Application for Works Approval

Works Approval Number W6507/2021/1

Applicant GSM Mining Company Pty Ltd

Premises Granny Smith Gold Mine

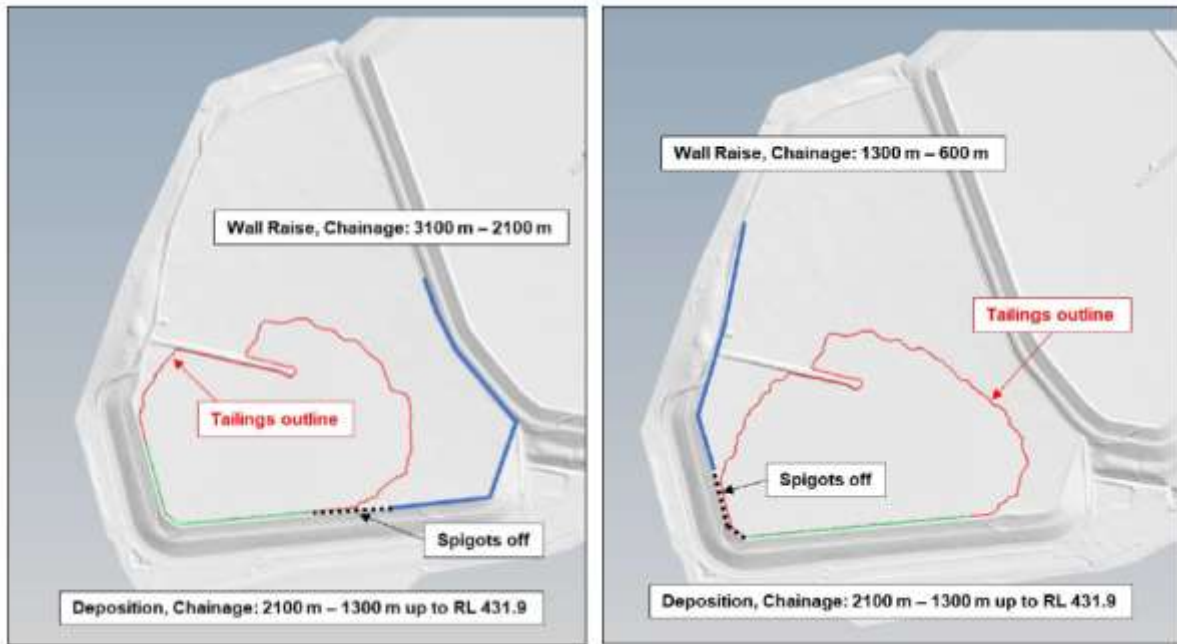
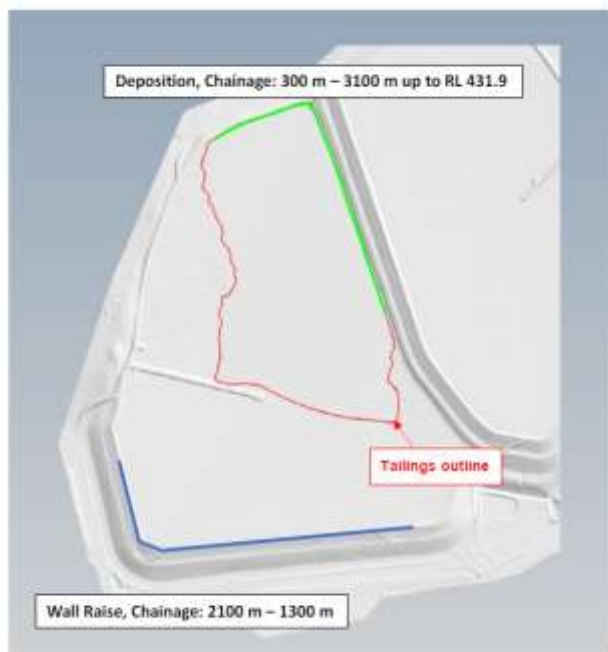
GSM's position is that deposition from the chainages indicated in green in the Figures in Schedule 1	The Delegated Officer accepts the Applicant's rationale that the deposition of tailings from the spigots

<p>is a more appropriate and practical prescription than deposition into the area enclosed by the red line.</p> <p>Deposition from the spigots is in direct control of GSM Operations, whereas the deposition extent is an output from advanced modelling.</p> <p>Regardless, regular monitoring and inspection of the deposition extent will be conducted to ensure the wet tailings do not impact on the construction chainages.</p>	<p>in areas away from the sections of chainage designated for construction will be more practical to monitor than if the deposition of tailings was restricted to an area of the TSF predicted by modelling inputs.</p> <p>Reference within the design and construction requirements for the 5 Stages of the TSF lift have been amended to reflect his change.</p>
	<p>The Decision Report states "The raise will result in a proposed maximum height of the embankments of 22.3 metres or 433.7 mRL, with tailings deposition permitted up to 433.4 mRL to account for the maintenance of the 300mm freeboard."</p> <p>GSM refers the DWER to Figures 4 - 9 of <i>Design Report in Support of Tailings Storage Facility Cell 3F Raise Works Approval Application</i> (Golder Associates, 2020) and Drawing 3 of <i>Technical Memorandum – TSF – Cell 3F Embankment Raise Staged Construction and Operations Addendum</i> (Golder, 2021). The design demonstrate that the maximum proposed crest elevation varies between 433.26m between 433.76 mRL.</p> <p>To maintain the minimum 300mm operational freeboard requirement, the maximum tailings operating level should be 433.46m for the sections where the constructed crest level is 433.76 mRL, with an additional 100mm of wearing course.</p> <p>The sections designed to a crest elevation of 433.26 mRL do not perfectly align with the chainages of each construction stage, and there are transitions between 1m and 1.5m embankment raises. Therefore, construction in accordance with the submitted design, or to a maximum of 433.76 mRL, is considered a more appropriate condition for all stages.</p>	<p>The Delegated Officer has considered the TSF raise to a maximum height of 433.7 mRL and tailings deposition to a maximum height of 433.4 mRL as this is what was stated in Section 1.1 of Attachment 3B – Proposed Activities, submitted to support the application form.</p> <p>In light of the additional clarification provided by the Applicant, the Delegated Officer has amended the maximum permissible height of the TSF raise to 433.76 mRL in line with the submitted drawings provided.</p> <p>Wording has also been updated in the Decision Report to reflect this change to the maximum height.</p>
